Field Safety Notice

Tissue-Tek® AutoSection®, Item# 5000, up to serial number 0297

Date: June 29, 2018

ALIGNMENT STEPS

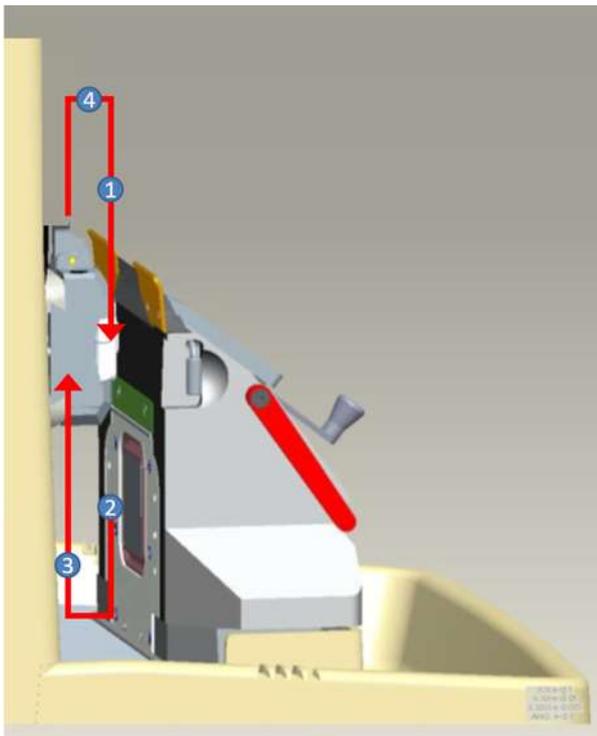
When software version 5.89 has been installed on the AutoSection and the emergency button is pressed before the alignment stage has been completed, the AutoSection will start sectioning (or facing) again after releasing the emergency button to reset the system.

Only during the first three steps of the alignment the issue will occur when the emergency button is pressed. The chuck will return to its upper position to reinitiate and will start without further notice after a few seconds.

Since the user will not anticipate the chuck to move at this stage, it is possible that the user is near the chuck (and therefore the blade) when the motion starts again. This poses a risk to user health.

Software version 5.90a which is expected to be released within 2 weeks, will be a mandatory upgrade in which this software bug is solved.

An instructed customer can still use the AutoSection in their daily routine while being alert that after an emergency stop within the before mentioned conditions the chuck will start moving again. This movement could simply be stopped by pressing the touchscreen like how one would normally stop the movement of the AutoSection.
